UNITED STATES DEPARTMENT OF COMMERCE
Patent and Trademark Office
Address: COMMISSIONER OF PATENTS AND TRADEMARKS
Washington, D.C. 20231

| APPLICATION NUMBER 05/19/98-236 | FILING DATE 11/18/98 | ARTERBURN | FIRST NAMED APPLICANT R | 6377 | DOCKET NO. |

OFFICE ACTION SUMMARY

DETAILED ACTION

FIG. 2

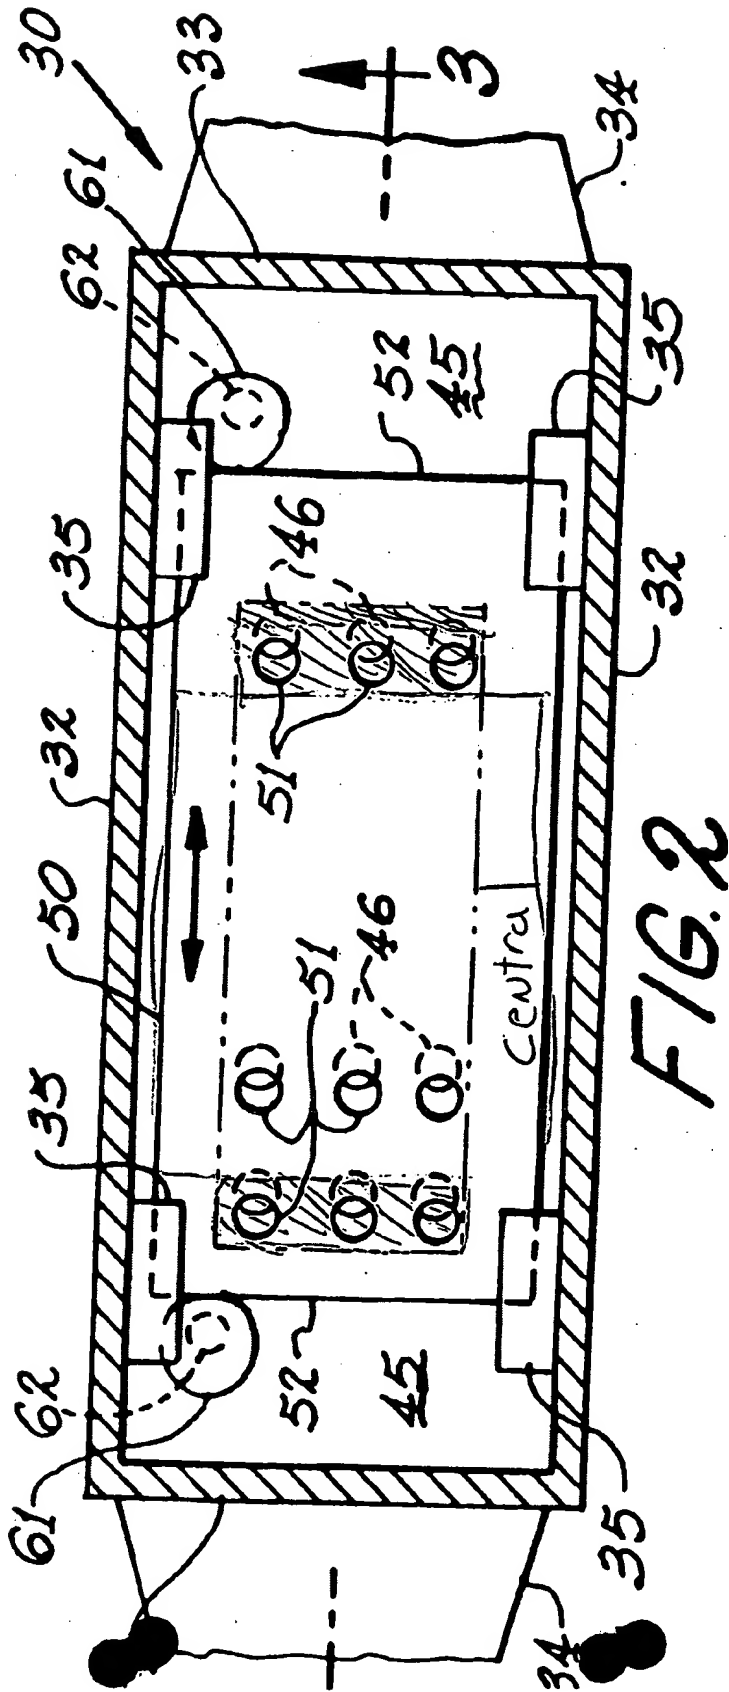
Please refer to the attached enlargement of figure 2. The two hatched sections are end portions; the yellow rectangle is a central portion. It is clear that the hole density in the center portion is significantly less than the hole density in the end portions. The resistance to flow in the central section is about 50% higher than in the end portions; the central portion has nine holes (see figure 3) - whereas the end portions have a total of six holes. This means that the central portion has $\frac{9}{6}$ ths the resistance as the end portions. If this is not inherent, one could redefine the end portions so that each end portion has only one hole in it - and then choose the hole which has the least amount of resistance
